FINAL DRAINAGE REPORT

LOT 2 PADMARK BUSINESS PARK FILING NO. 1

(LOT 44 OF CLAREMONT BUSINESS PARK FILING NO. 2)
EL PASO COUNTY, COLORADO

Project #44-031
DSD Project #PPR-17-004

Detention Basin Outlet Structure Design

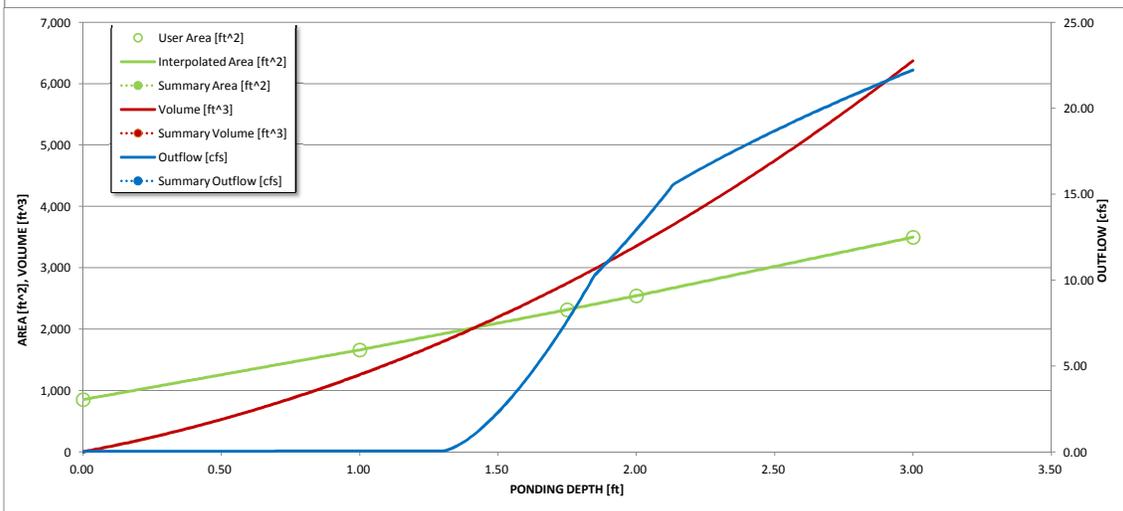
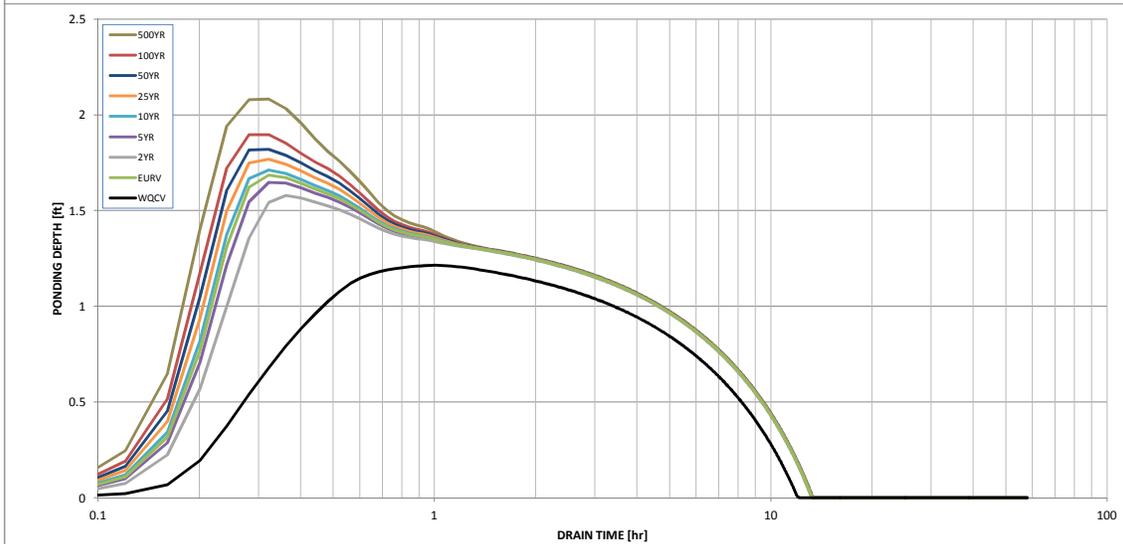
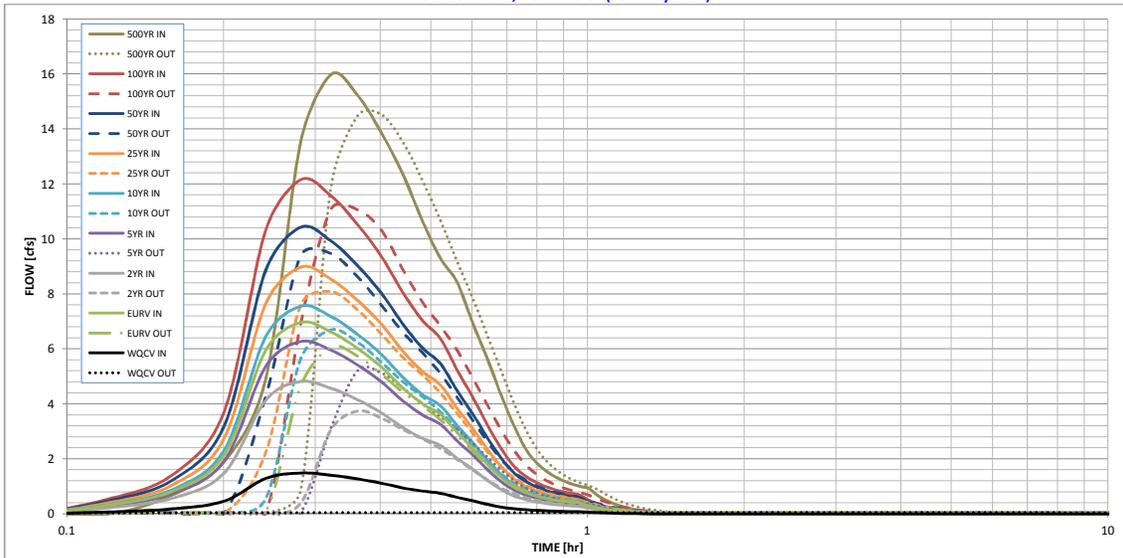
Per the GEC the depth from the spillway crest to bottom of the SF is 1.75' which is less than the calculated 100 yr ponding depth which means portion of the 100yr developed flow is overtopping the emergency spillway. Revise the spillway elevation.

SAND FILTER POND/SPILLWAY
 DETAIL

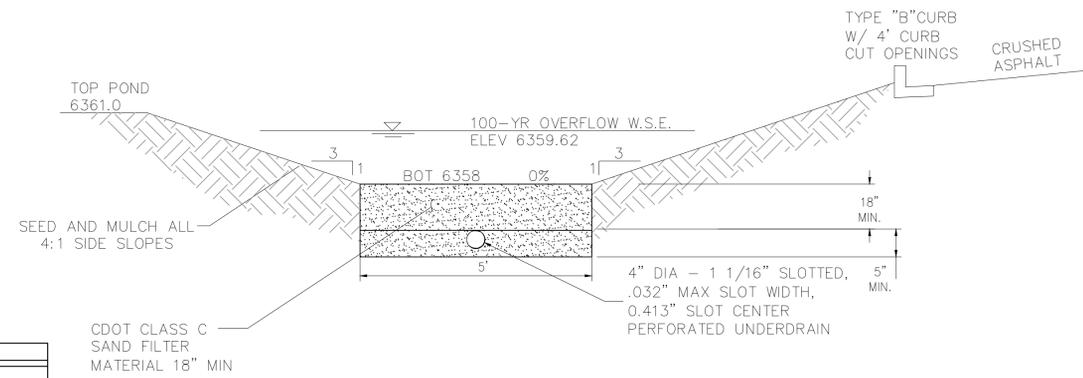
Per the GEC the depth from the spillway crest to bottom of the SF is 1.75' which is less than the calculated 100 yr ponding depth which means portion of the 100yr developed flow is overtopping the emergency spillway. Revise the spillway elevation.
